METRICON (QLD) PTY LTD
 ALTITUDE 1 - FRASER DRV. TERRANORA
 BUILDING PAD LAYOUT & SECTIONS
 Sheet 3 of 3

ALTITUDE 1
Subject: Minutes of DAP Meeting
Tweed Shire Council
26 March 2010.

Proposal: Proposed 300 Lot Subdivision (Major Project 09_0166 Altitude 1 Development at Terranora). This proposal known as Altitude 1 forms part of the broader Urban Release Area known as AREA E.

DRAWING NUMBER: **OPTION 2**

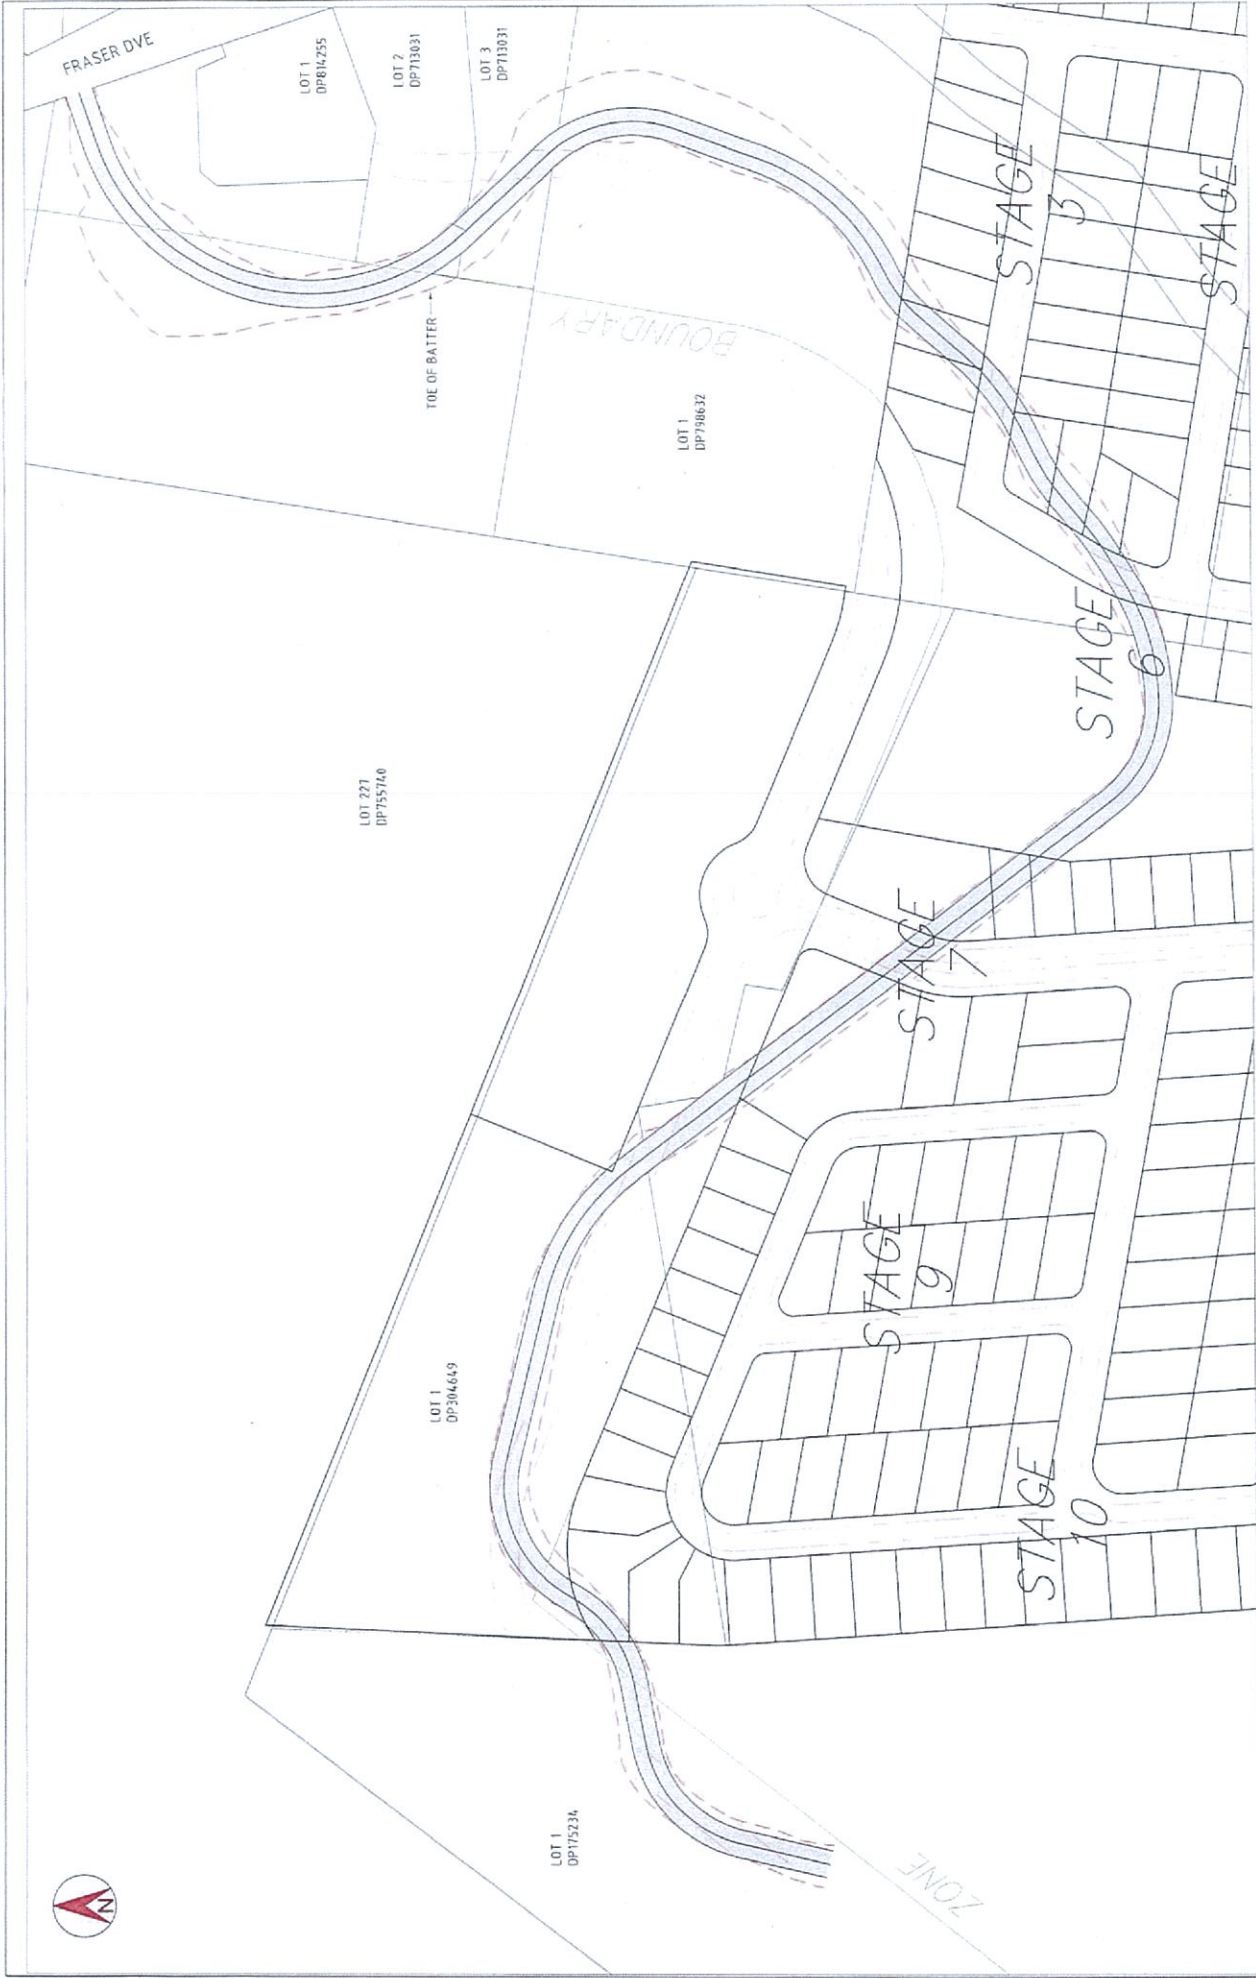
Patrick Knight tabled two concept design options for the alignment of Broadwater Parkway copies of which are attached. Option 1 only involves acquisition from two properties and is preferred in that respect. However, **Brian** as discussed could you refine the design and address the intersection spacing including, if possible, moving the

alignment to the east to avoid the EEC and locating the alignment in the outer 50m of the 100m wetland buffer. You can obtain CAD copies of the drawings from Paul Morgan (paulm@tweed.nsw.gov.au).

Option 2 in my view does not warrant further consideration in view of its obvious implications for Altitude 1.
